September 8, 2004

MEMORANDUM TO: John T. Larkins, Executive Director  
Advisory Committee on Reactor Safeguards

SUBJECT: REQUEST FOR ACRS REVIEW OF THE DRAFT SAFETY  
EVALUATION BY THE OFFICE OF NUCLEAR REACTOR  
REGULATION RELATED TO NRC GENERIC LETTER 2004-xx,  
NUCLEAR ENERGY INSTITUTE GUIDANCE REPORT (PROPOSED  
DOCUMENT NUMBER NEI 04-07), "PRESSURIZED WATER REACTOR  
SUMP PERFORMANCE EVALUATION METHODOLOGY"

**SAFETY EVALUATION BY  
THE OFFICE OF NUCLEAR REACTOR REGULATION  
RELATED TO NRC GENERIC LETTER 2004-XX,  
NUCLEAR ENERGY INSTITUTE  
GUIDANCE REPORT  
(PROPOSED DOCUMENT NUMBER NEI 04-07),  
“PRESSURIZED WATER REACTOR  
SUMP PERFORMANCE EVALUATION METHODOLOGY”**

**Figure 3-1. Comparison of GR Isobar Map with Isobars from Independently Evaluated ANSI Jet Model**

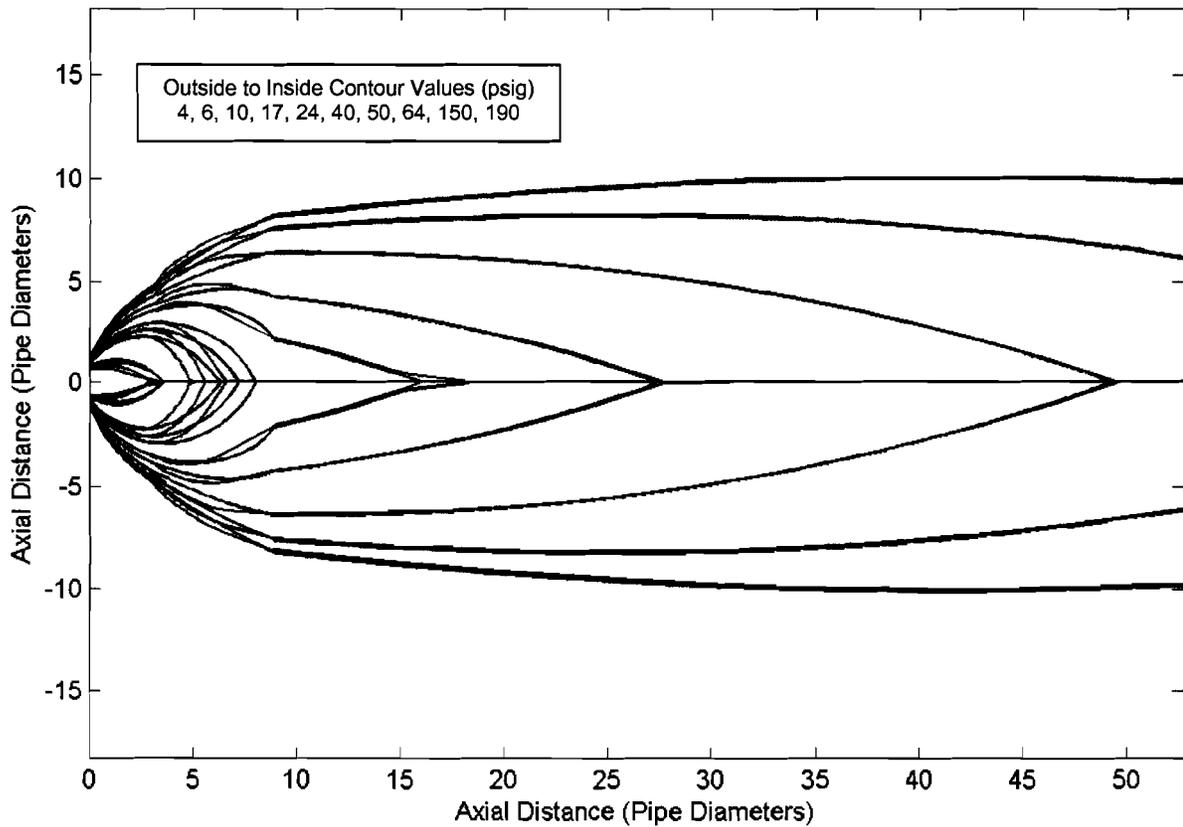
Good agreement is seen between the calculations for downrange behavior (Zone 3), but discrepancies exist in Zones 1 and 2. It appears that contour termination points on the centerline are not accurate and that the quadratic behavior of the Zone 2 isobar equations is not implemented correctly. These differences will have a negligible effect on volume integrals for jet pressures less than 20 psig, but may become more of a concern for higher pressures near the break. To quantify the magnitude of the difference, Table 3-1 below presents a comparison of ZOI radii computed from both methods. In particular, the GR approach may not have preserved the system stagnation pressure throughout the volume of the liquid core region as specified by the standard. However, the GR recommended values essentially bound both sets of calculated values.

**Figure I-1. ANSI Jet-Model Stagnation Pressures for PWR Cold-Leg Break Conditions (530°F, 2250 psia)**

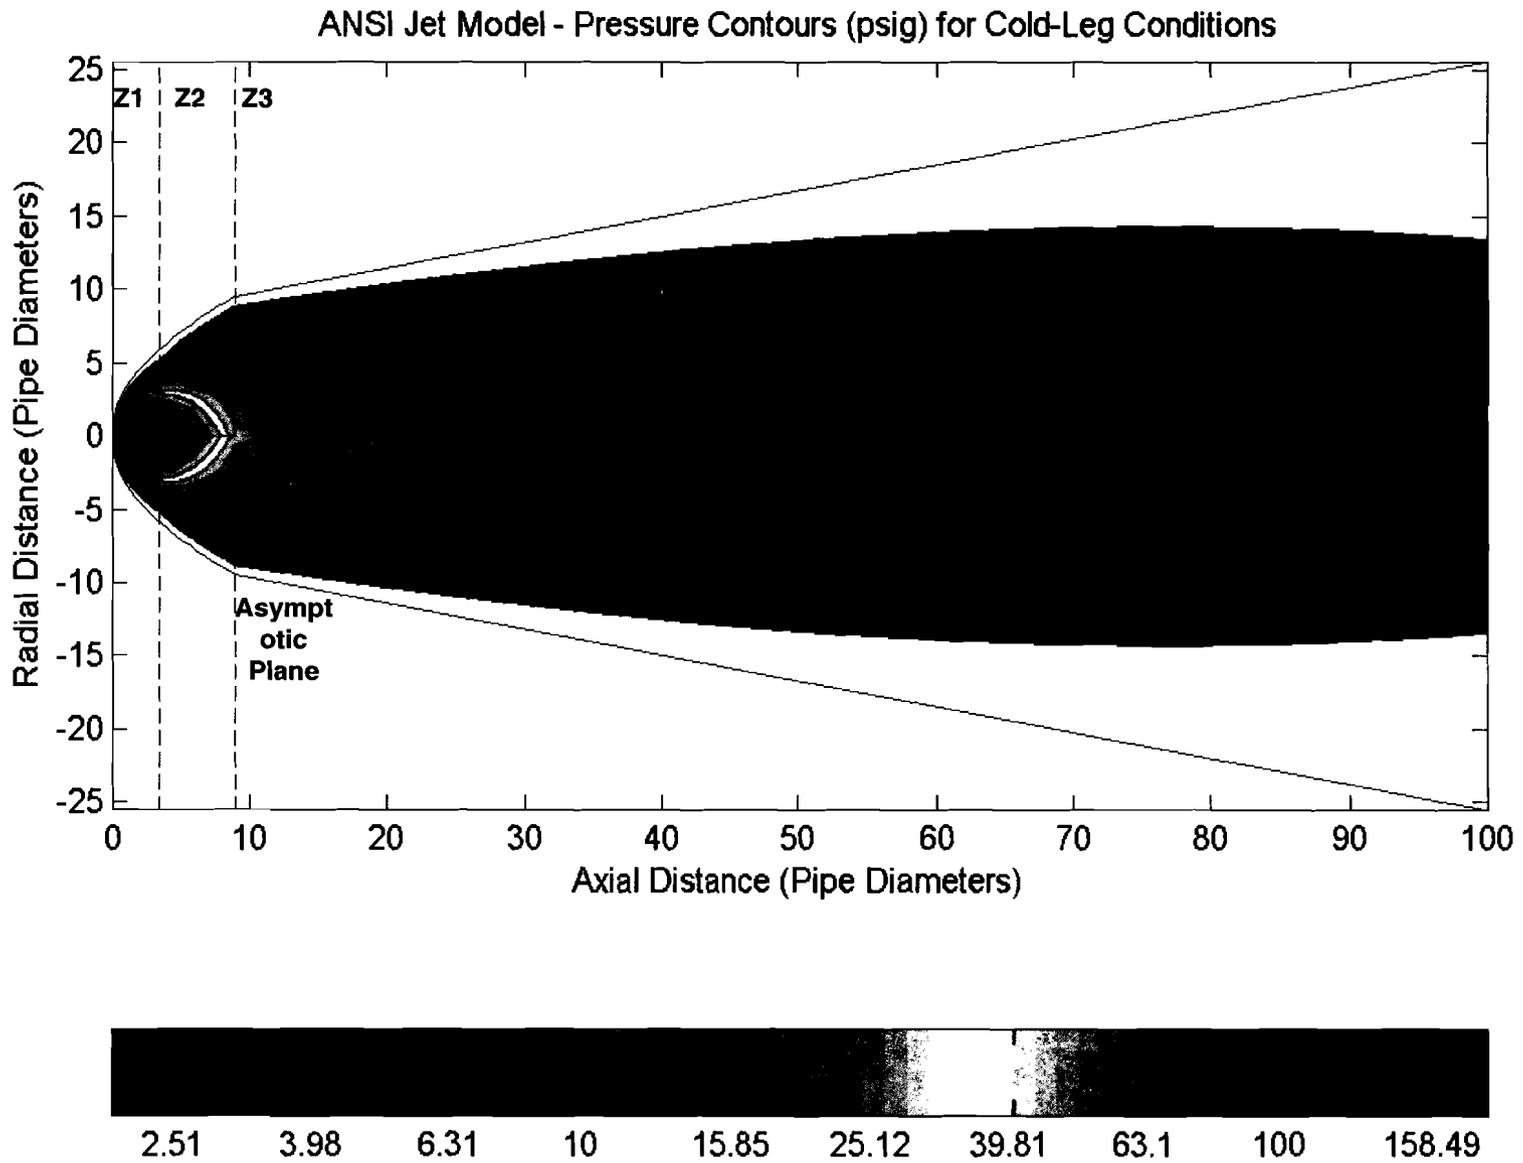
These attributes of the model suggest that calculated pressures represent jet impingement conditions that would be experienced in a direction parallel to the midline only. Actual stream lines in a rapidly expanding jet must have a significant radial velocity component in order to create the characteristic envelope shown in Figure I-1, so in a sense, the predicted pressures represent only the longitudinal component of the local, momentum-dominated, total jet pressure. The implication of this interpretation is that true local impingement pressures as measured normal to realistic flow directions in the jet may be underestimated, particularly in Zones 1 and 2, where radial expansion is greatest.

Although a computed pressure isobar may be smaller in radius than that of the corresponding local impingement pressure that is desired for debris generation estimates, it may also be longer in the downstream direction. Comparative elongation of isobars from the jet model occurs because the entire mass flux ejected from the break is assumed to pass through the jet cross section at the asymptotic plane. Thus, the forward momentum of the jet is maximized in a manner that would be considered conservative for structural loading calculations. Unrealistic isobar elongation may also be predicted because the jet-centerline pressure equation for Zone 3 is inherently unbounded; that is, the centerline gauge pressure only falls to zero as the jet diameter grows infinitely large at infinite distance. It is impossible to quantify the net effect on isobar volume of these disparities between the ANSI model and the desired free-expansion impingement pressures without a complete understanding of the experimental measurements on which the model is based; however, the mathematical properties of the pressure equations are certain to exaggerate the length, and hence the volume, of low-pressure isobars.

The sharp tip of each contour shown in Figure I-1 is another nonphysical feature of the ANSI model that arises from lack of attention to matching spatial first derivatives. It might be expected that each isobar be smoothly bounded and have infinite slope at the terminal point, especially at very low pressures where the jet returns to ambient conditions. It is helpful to know the distance to the terminal point of each contour for iterative integration of spatial volumes. These points can be found by solving the centerline pressure Equations (I-21) and (I-23) for distances  $L_t$  corresponding to the desired pressure. Note that there are no terminal points in Zone 1 except for the jet core.

- A discontinuity in the slope of the isobars exists between Zones 2 and 3. This discontinuity is clearly evident in Figure I-1. The sharp terminal points of pressure isobars at the axial centerline also suggest that more attention could be given to the behavior of first spatial derivatives.

**Figure I-17. Comparison of ANSI Jet-Model Equivalent Spherical Radii for Six Initial Break Conditions**

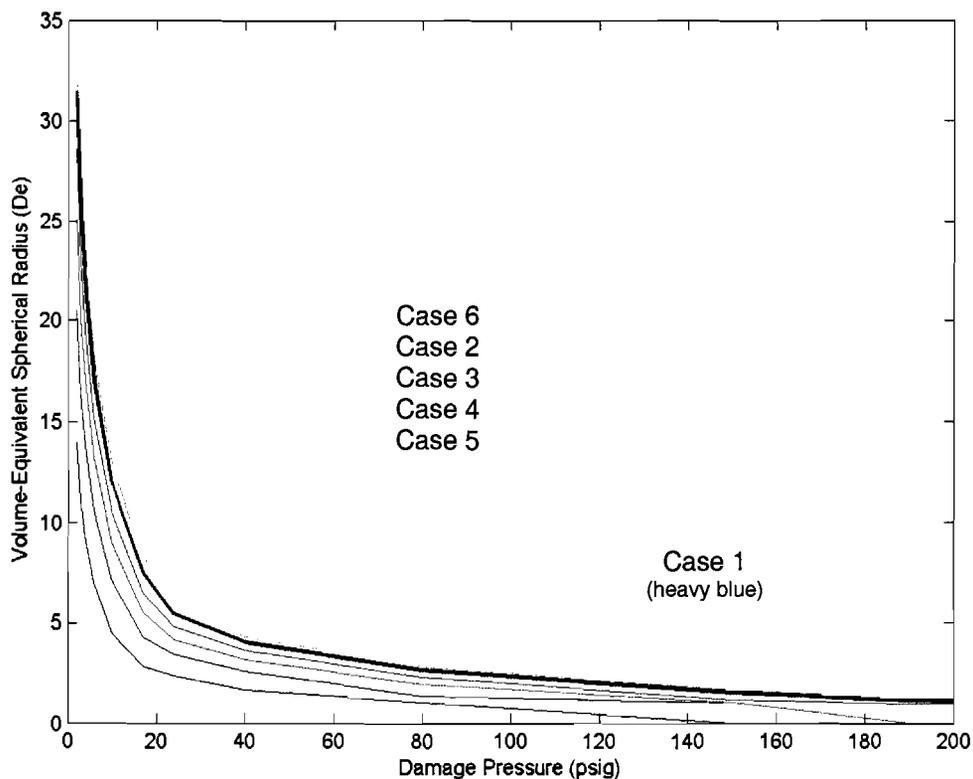
correlation is the reason that the Figure I-17 abscissa is labeled as “Damage Pressure.” Case 1 represents a previously studied hydraulic condition [RAO02] that will be used as the reference case. Reading from the figure, a damage pressure of 10 psig corresponds to an equivalent jet radius of approximately 12 pipe diameters. Note that equivalent radii climb sharply for damage pressures below 20 psig.

This set of calculations suggests that the state-point pressure of the jet dominates the determination of isobar volumes. Other cases that are not shown in Figure I-17 were bounded by Case 1. Case 7, the nominal PWR cold-leg condition recommended in the GR, was almost indistinguishable from Case 1. Case 8, a nominal hot-leg break condition, was also bounded by the reference case except at damage pressures greater than 120 psig. Hot-leg conditions are much closer to saturation (630°F vs. 653°F); therefore, the shapes of the pressure contours change near the core. Case 6 was run as a perturbation check for plants that may at times have higher operating pressures than the nominal value of 2250 psig. Although the pressure increase was 10% higher than the reference, the maximum deviation in spherical volume was only 8%; therefore, a linear adjustment for higher pressure would be conservative in the absence of a full jet-model analysis.

Figure VI-2. LDFG Damage Curve for Small Fine Debris.

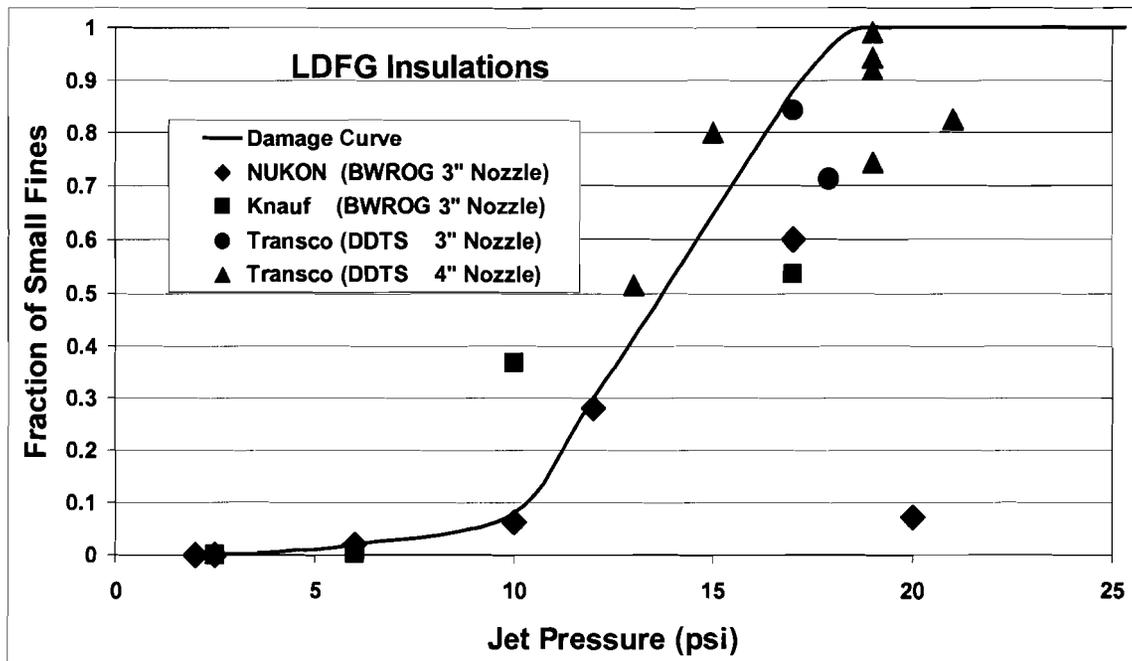
Another significant point of discussion is that the threshold of damage for LDFG insulation has been specified as 10 psi, where Figure II-2 clearly shows damage at jet pressures <10 psi. Apparently, neglecting the tail of the damage curve was considered acceptable for the BWR strainer resolution because of the lesser BWR jet volumes at lower pressures, as shown in Figure II-1. However, the much larger jet volumes below 10 psi for the PWR jet shown in Figure II-1 make the neglect of the tail less acceptable.
